# Addendum Report to Landscape and Visual Appraisal (Tyler Grange, September 2020 2399/R07/EF/RH)

## Land off Kyderminster Road, Winchcombe

February 2021

1. This Addendum Report has been by Turley Landscape and VIA on behalf of the client, Firststeel to accompany a revised application for outline planning permission (ref 20/00892/OUT) for a proposed residential development on land off Kyderminster Road, Winchcombe.

**Figure 1: Visibility of the site from public rights of way on Langley Hill (Green – Site not visible Red- glimpsed views)**

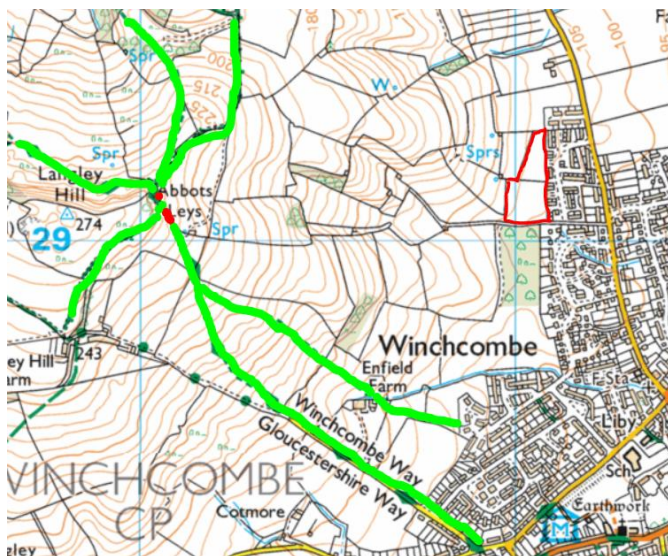
9. It was observed that in views from the west from public rights of way on and around Langley Hill, the Site is predominantly screened from view by landform and/or vegetation in the intervening area from virtually all parts of the paths (indicated in green on Figure 1 below). There are occasional glimpsed views from a very short stretch of one public footpath (indicated in red on Figure 1 below and illustrated as RV13 within the LVA) where a corner of the Site can be glimpsed in the distance beyond a hedgerow. However, these are fleeting, incidental views in which the Site is barely noticeable. They are not an important or strategic viewpoint and the Site is a small and insignificant part of the view. The more important features of these views which make the main contribution to visual amenity, are the escarpment slopes of the Cotswold Hills which forms a distinctive horizon and the settlement of Winchcombe which nestles in the valley.

**Figure 3: Location of WIN1 site (hatched red) identified in Emerging Tewkesbury Borough Plan (2011 - 2031)**

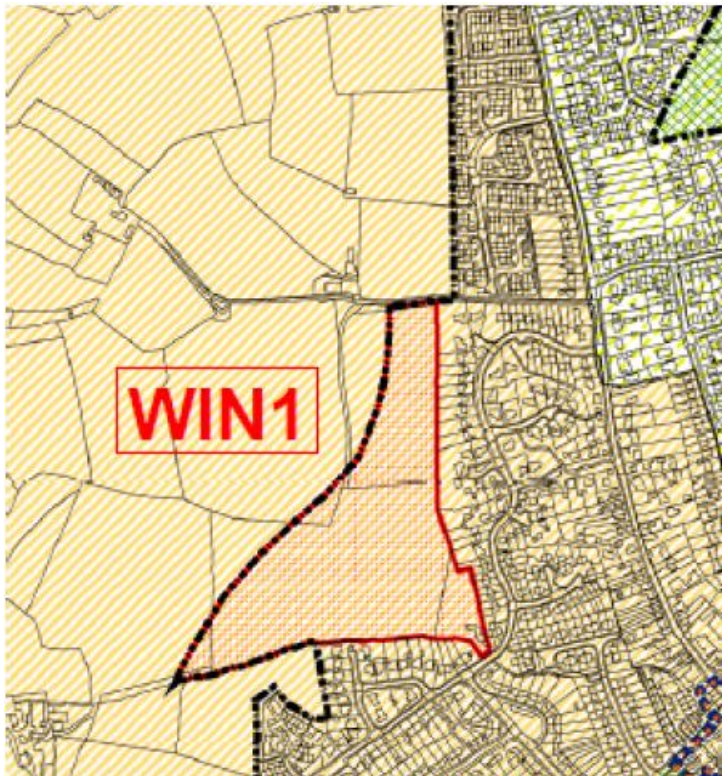
42. Site WIN1 is located adjoining the Kyderminster Road Site to the south and is separated by a farm track (Figure 3). There is limited intervisibility between the two sites due to the presence of mature vegetation either side of the track. Development proposals are not yet available but the draft policy identifies the site for residential development with all development to be located below the 115m AOD contour.
